Access Compliance Report

Public Rights-of-Way

(Curb Ramps)

Intersection ID: 53339	Main Street: NORTHLAKE CENTRE PY	Cross Street: CALHOUN ST	Location: NW
ADA ID: 4D47FE313A56	Ramp Type: Perp	Initial Pass/Fail: Fail	Overall Compliance: No
Codes/Mitigation Info/Possible Solution		Field Measurements/Component Compliance	
Severity Score: 8.75

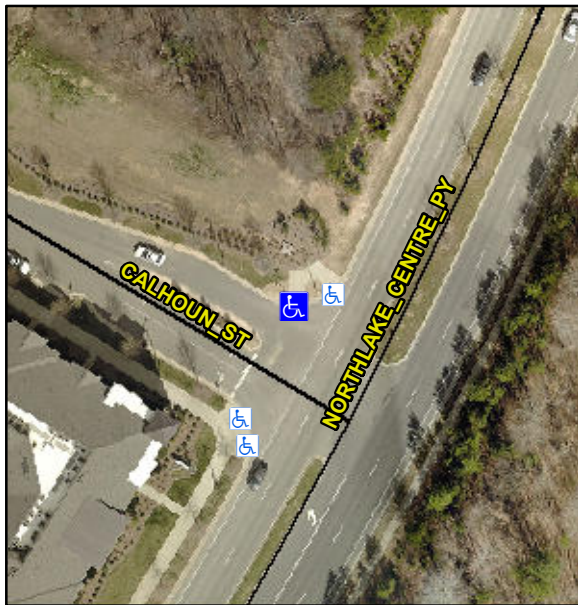
R304.5.1

Compliance	Description	Data	Compliance	Description	Data
N/A	Ramp Length (in)	98.0	Yes	Ramp Slope (%)	6.5
No	Ramp Width (in)	46.0	Yes	Ramp XSlope (%)	1.1
N/A	Flare Type LT	N/A	N/A	Flare Type RT	N/A
N/A	Flare Slope LT (%)	N/A	N/A	Flare Slope RT (%)	N/A
N/A	Flare Traversable LT?	N/A	N/A	Flare Traversable RT?	N/A
N/A	Landing Length (in)	N/A	N/A	DWS Provided?	N/A
N/A	Landing Width (in)	N/A	N/A	DWS Contrast?	N/A
N/A	Landing Slope (%)	N/A	N/A	DWS Length (in)	N/A
N/A	Landing X Slope (%)	N/A	N/A	DWS Full Width?	N/A
N/A	Landing Curb? (Y/N)	N/A	N/A	DWS Offset (in)	N/A
N/A	Shared Landing?	N/A			
N/A	Gutter Ponding?	N/A	N/A	Gutter Slope (%)	N/A
N/A	Gutter Lip Ht (in)	N/A	N/A	Gutter X Slope (%)	N/A
N/A	Painted X Walk1?	No	N/A	Painted X Walk2?	N/A
	X Walk 1 Direction	To SW		X Walk 2 Direction	N/A
N/A	X Walk 1 Width (in)	N/A	N/A	X Walk 2 Width (in)	N/A
	X Walk 1 Slope (%)	0.5		X Walk 2 Slope (%)	N/A
	X Walk 1 X Slope (%)	0.1		X Walk 2 X Slope (%)	N/A

Remove & Replace Entire Ramp.
